OIL CONSERVATION DIVISION
1220 South St. Francis Dr.
Santa Fe, NM 87505

| 7. Lease Name or Unit Agreement Name W.D. Grimes NCT-A ✓ |
| 8. Well Number #4 ✓ |

SUNDRY NOTICES AND REPORTS ON WELLS
(DO NOT USE THIS FORM FOR PROPOSALS TO DRILL OR TO DEEPEN OR PLUG BACK TO A
DIFFERENT RESERVOIR. USE "APPLICATION FOR PERMIT" (FORM C-101) FOR SUCH
PROPOSALS.)

Proposed P&A Wellbore Schematic

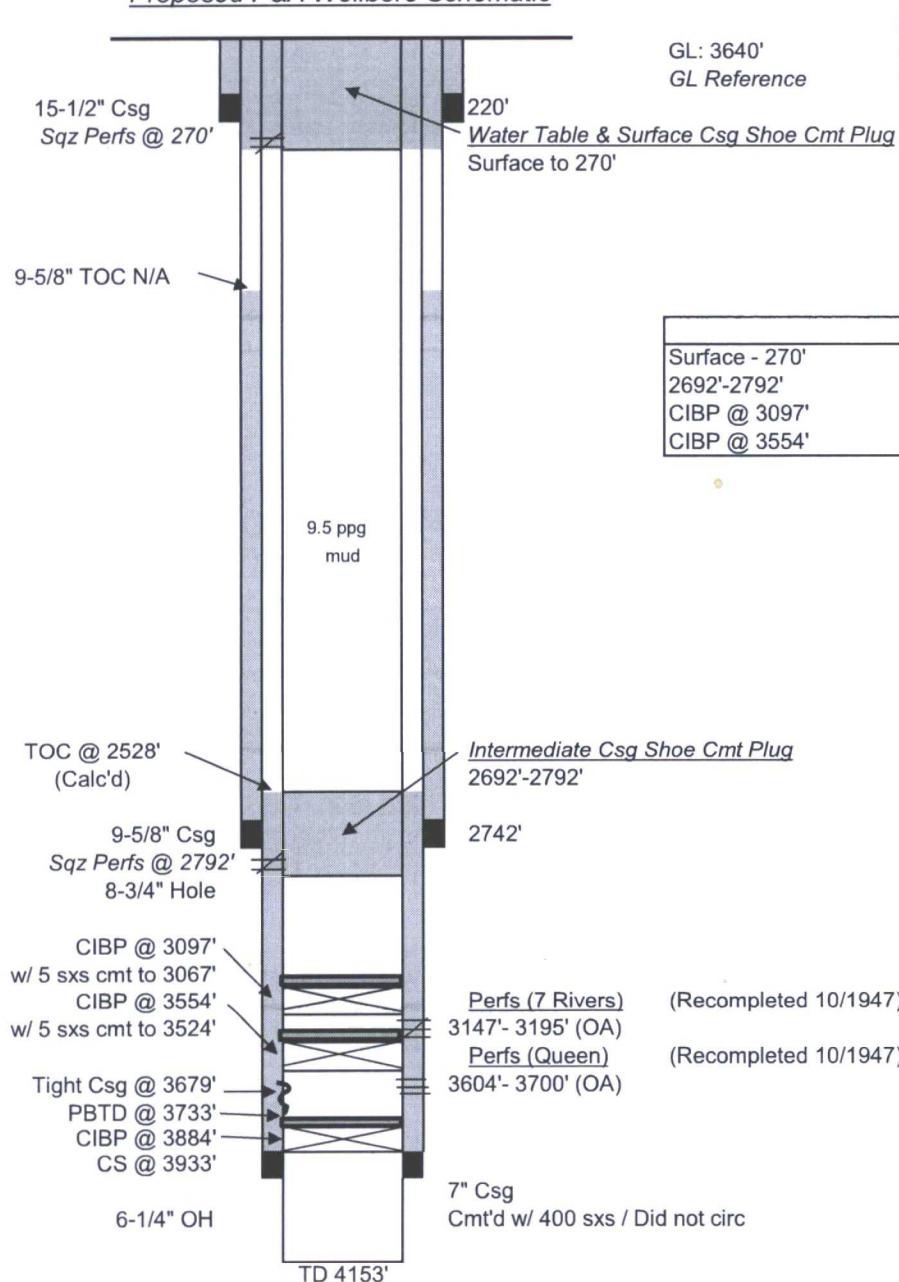
4. ~~Spot 25 sk plug @ 3524' - 3554'~~

30 SX 5. Spot 25 sk plug @ 3250', Tag plug

6. ~~Spot 25 sk plug @ 3067' - 3097'~~

7. SPOT 35 SX PLUG @ 2850'. WOC & TAG (B. SALT/SHOE PLUG)

30 SX 8. Spot 25 sk plug at 1850' (top of salt) ← PERFORATE & SQZ. WOC & TAG

Verify cmt. to surface all strings
